# CHARTER TOWNSHIP OF GARFIELD PLANNING COMMISSION MEETING

AGENDA

Charter Township of Garfield  Planning Department Report No. 2023-83					
Prepared:	July 5, 2023	Pages: 6			
Meeting:	July 12, 2023 Planning Commission	Attachments:			
Subject:	Village at Garfield Special Use Permit-Public	Hearing			
File No.	SUP-2023-03	Parcel No. 05-023-042-01			
Applicant:	Brian Stadler/Outlook Development, LLC				
Agent:	ent: Andrew Purvis, P.E./Gosling Czubak Engineering Services, Inc.				
Owner:	Brian Stadler/Hammond LDHA LP

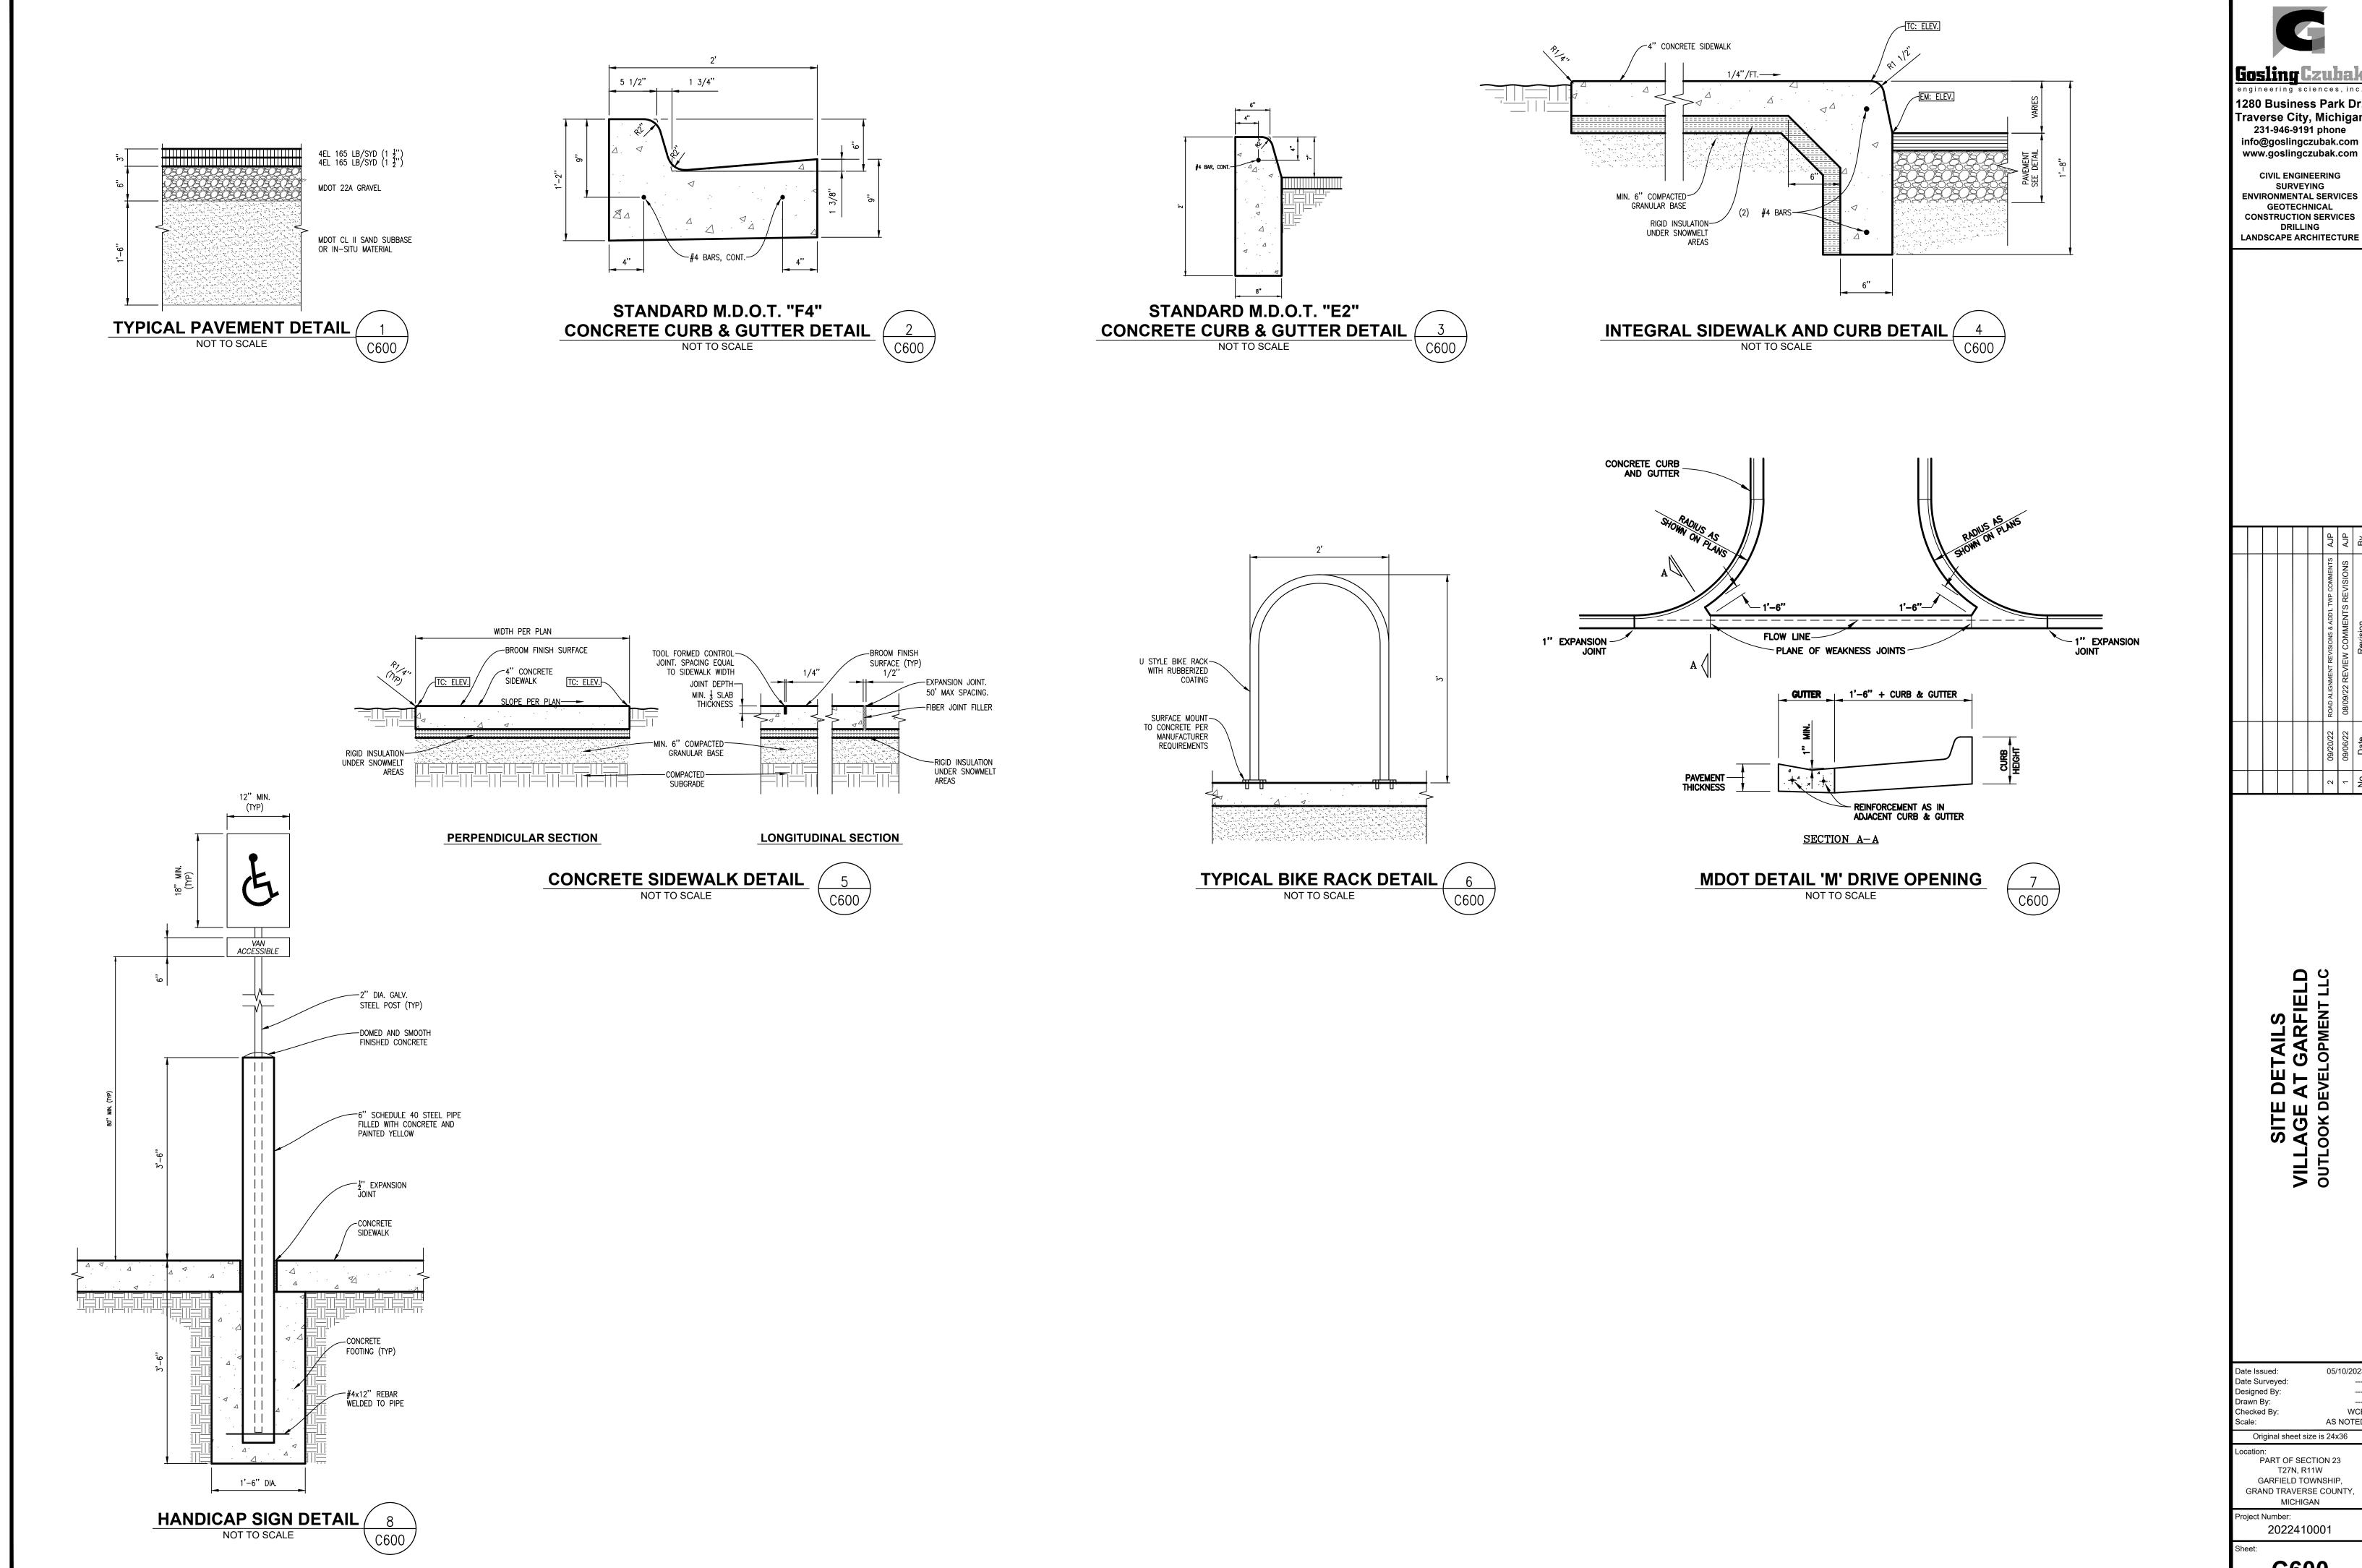
Snow storage is to be provided at the ratio of ten (10) square feet per one hundred (100) square feet of parking area. A snow storage area has been identified and meets the minimum requirements. See location number 9 on sheet C200. However, all snow storage is concentrated at one location near the driveway entrance. Several snow storage locations dispersed around a site are typically what is proposed in site plans. Dispersed locations are more convenient and efficient for plowing and should be considered for the site.

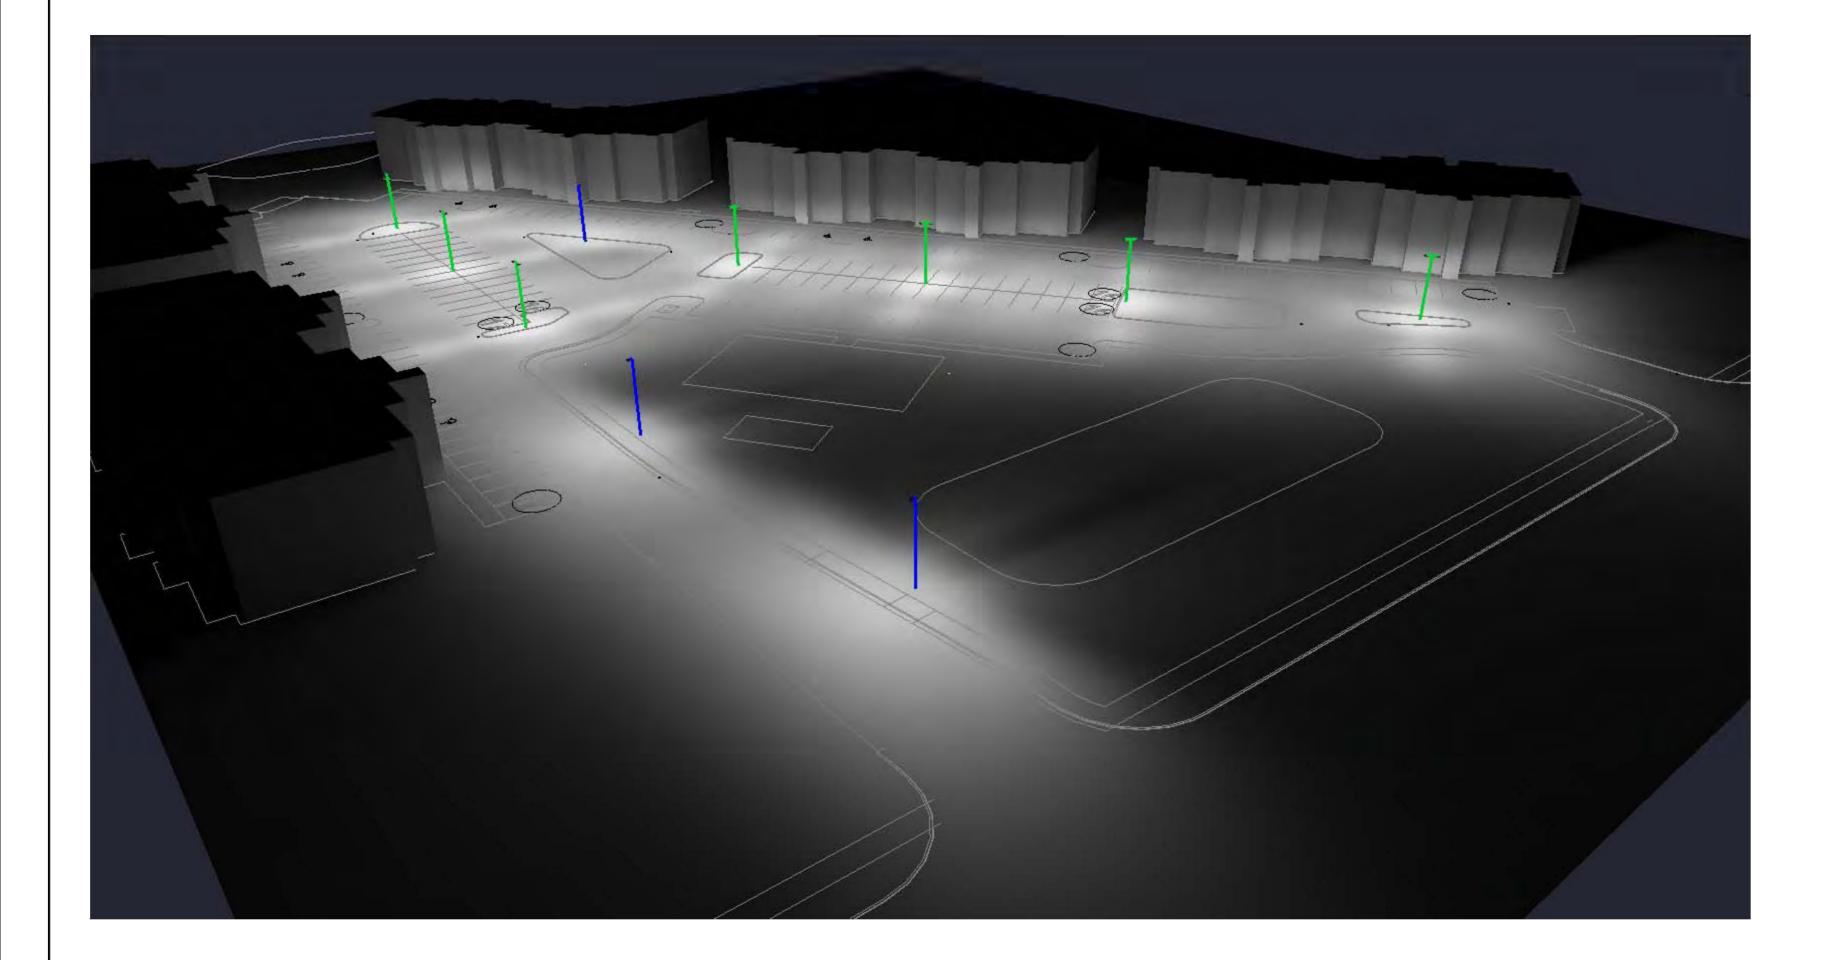
The applicant has indicated that the photometric site plan is being revised to incorporate lighting fixtures that comply with the color temperature requirements.
